I, Scott M. McGee, NMPE No. 10519 of the firm Isaacson & Arfman, P.A. hereby certify that this project has been graded and will drain in substantial compliance with and in accordance with the design intent of the approved plan dated 09-28-07. The record information edited onto the original design document has been obtained by Andrew S. Medina, NMPS #12649 of the firm Sandia Land Surveying LLC. I further certify that I or a member of my firm under my direct supervision have visited the project site on 8-12-08 and have determined by visual inspection that the survey data provided is representative of actual site conditions and is true and correct to the best of my knowledge and belief. This certification is submitted in support of a request for permanent Certificate of Occupancy.

AREAS OF MODIFICATION BETWEEN APPROVED DRAINAGE GRADING PLAN AND ACTUAL AS-BUILT

Cibola Energy
Corporation
Office Remodel
1429 Central NW
Albuquerque, NM 87104

GRADING AND DRAINAGE PLAN

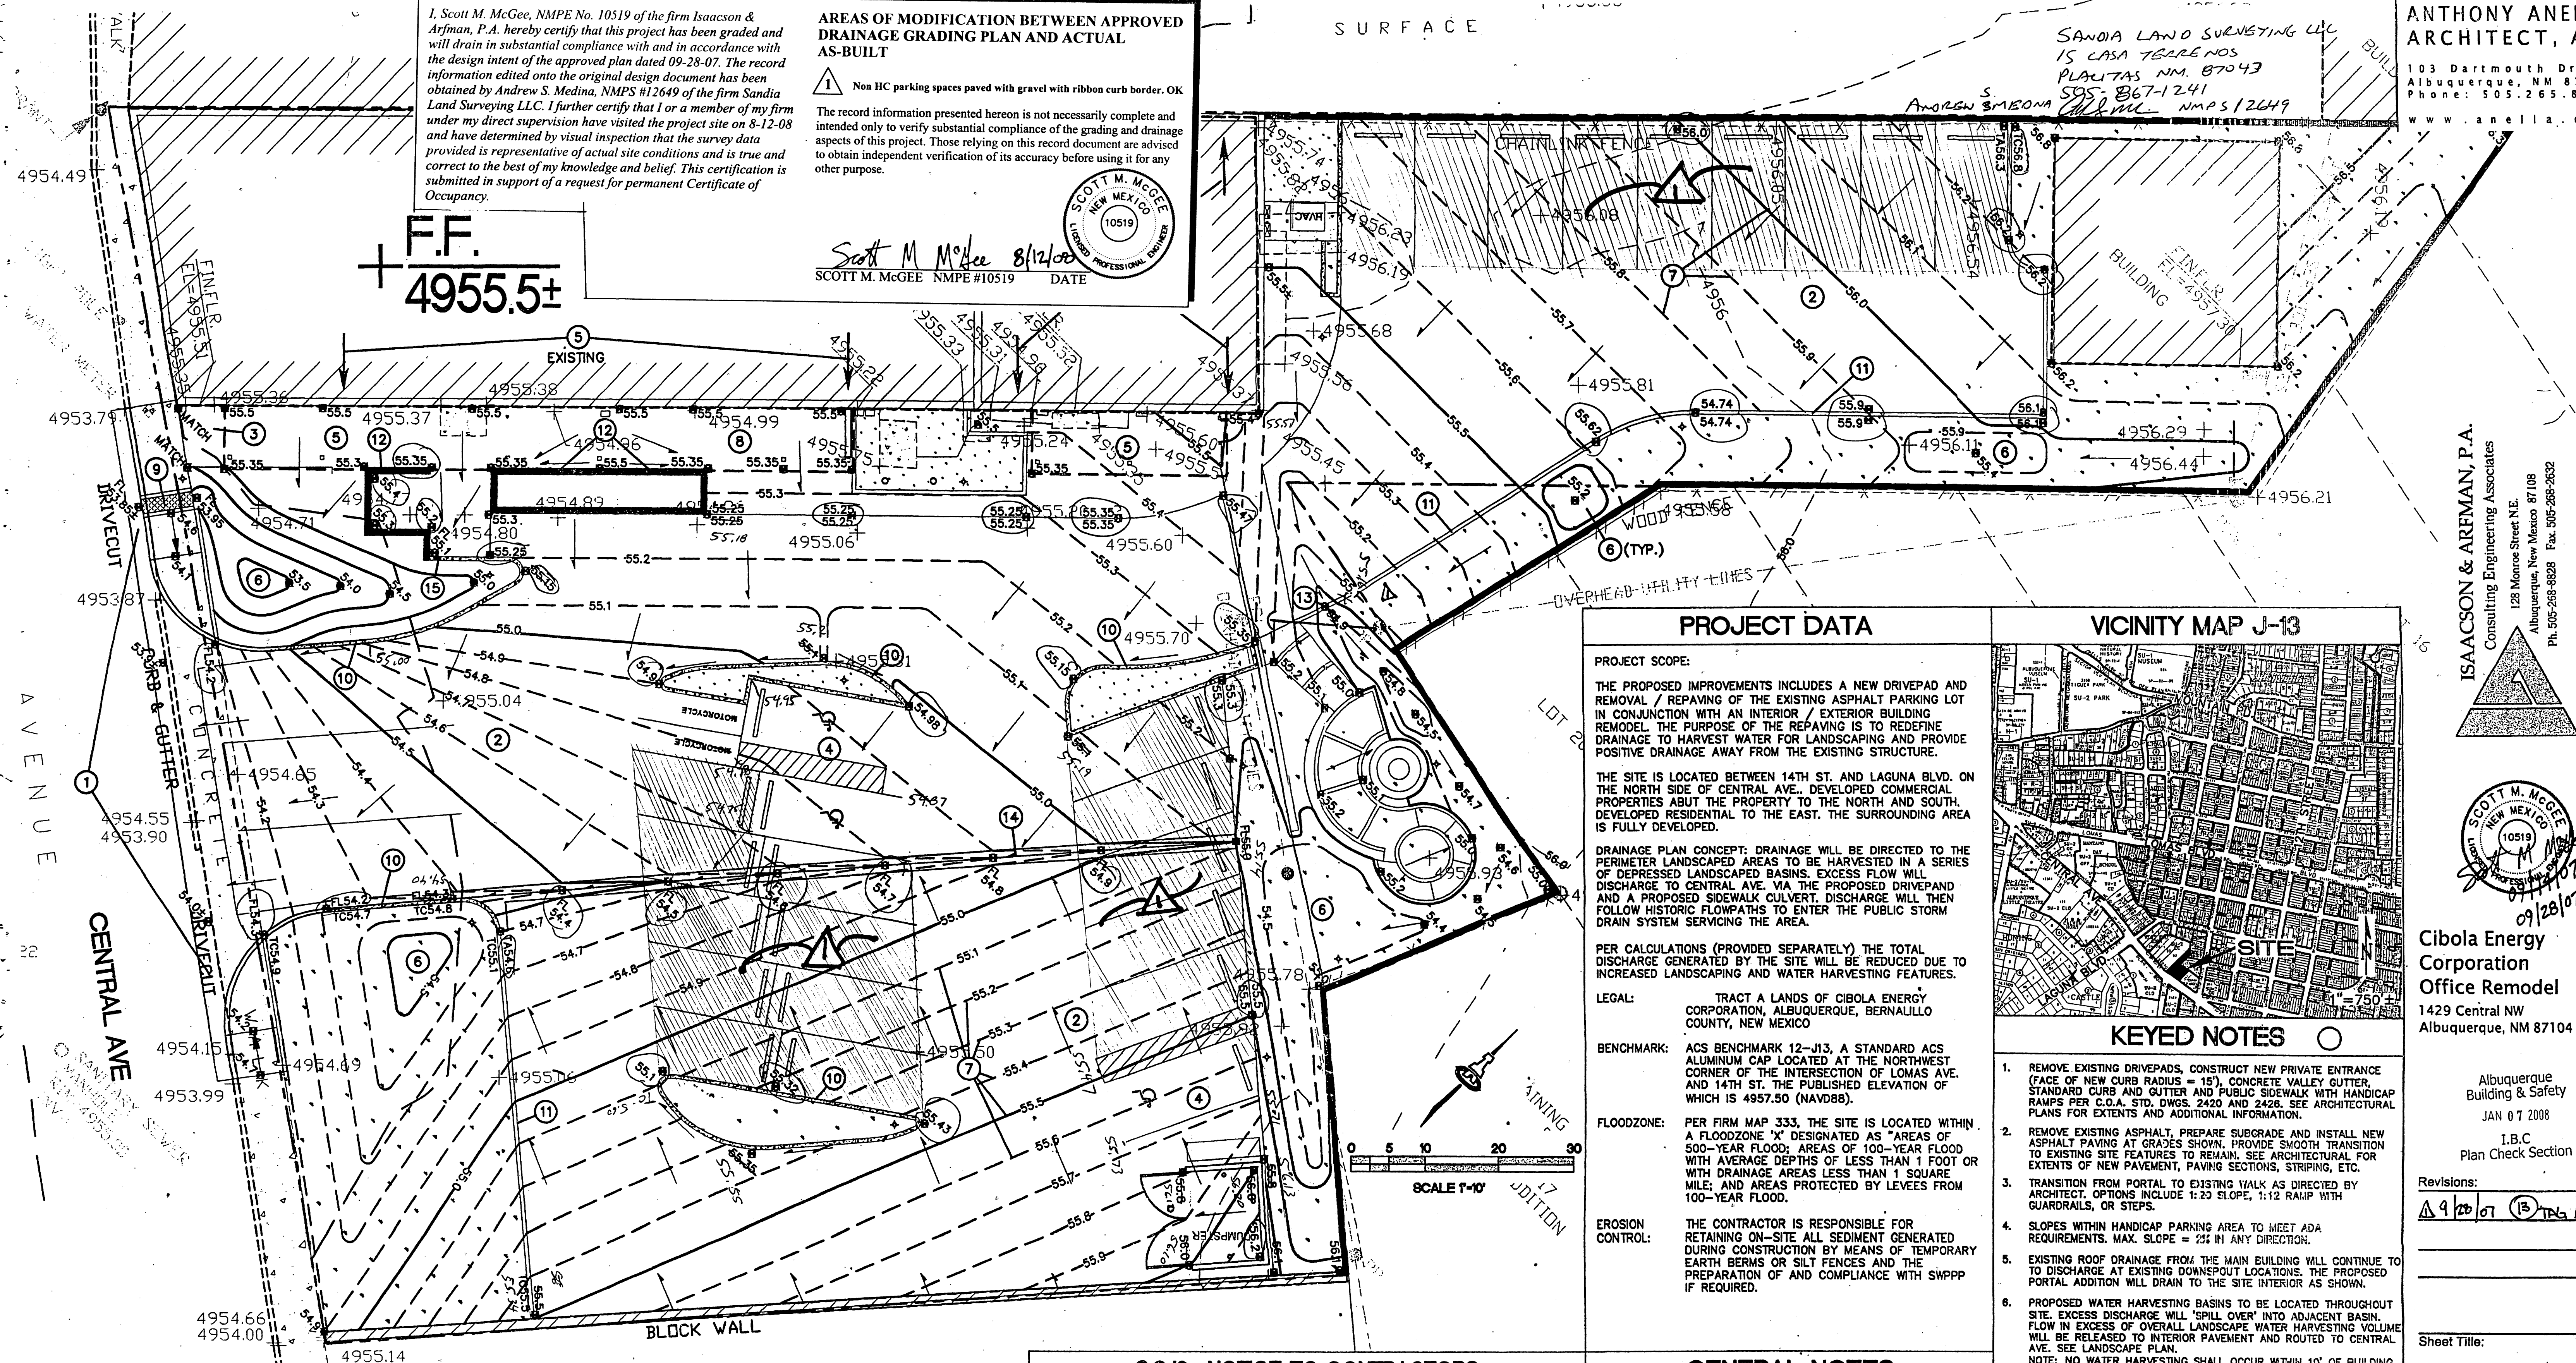
1 Non HC parking spaces paved with gravel with ribbon curb border, OK
